Access Compliance Report

Public Rights-of-Way (Curb Ramps)

Intersection ID: 30079	Main Street: HARRIS_HOUSTON_RD	Cross Street: HOUSTON_HEIGHTS_RD	Location: NW
ADA ID: EEC4C68B997E	Ramp Type: Perp	Initial Pass/Fail: Fail	Overall Compliance: No
		Severity Score: 22.5

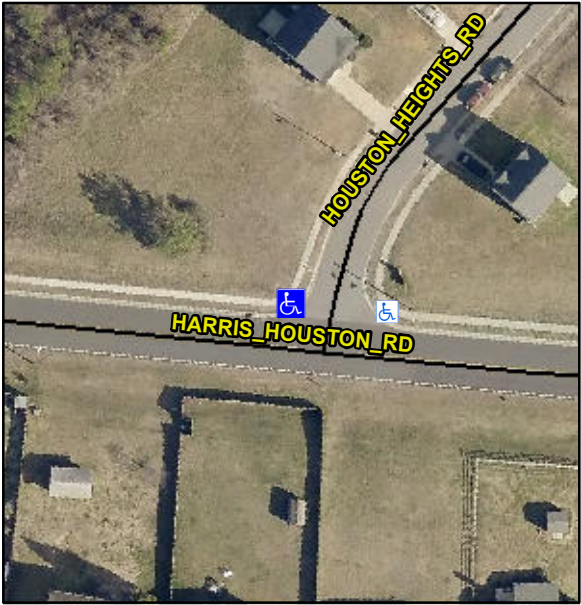
Codes/Mitigation Info/Possible Solution		Field Measurements/Component Compliance			
 Street 1 Name HOUSTON HEIGHTS RD Stop Condition-Street 2 StopSign Street 2 Name N/A Stop Condition-Street 1 N/A	Possible Solutions:	Remove & Replace Entire Ramp.			
	Surveyor Notes:	N/A			
	PROW/ADA:	R304.5.1, R304.2.2, R304.5.3			
			Compliance	Description	Data
			No	Ramp Length (in)	48.0
			No	Ramp Width (in)	47.0
			N/A	Flare Type LT	N/A
			N/A	Flare Slope LT (%)	N/A
			N/A	Flare Traversable LT?	N/A
			N/A	Landing Length (in)	N/A
			N/A	Landing Width (in)	N/A
			N/A	Landing Slope (%)	N/A
			N/A	Landing X Slope (%)	N/A
			N/A	Landing Curb? (Y/N)	N/A
			N/A	Shared Landing?	N/A
			N/A	Gutter Ponding?	N/A
			N/A	Gutter Lip Ht (in)	N/A
			No	Painted X Walk1?	N/A
				X Walk 1 Direction	To E
			N/A	X Walk 1 Width (in)	N/A
				X Walk 1 Slope (%)	2.1
				X Walk 1 X Slope (%)	3.3
			N/A	Ramp inside XWalk1?	N/A
				Road Slope (%)	N/A
				Road X Slope (%)	N/A
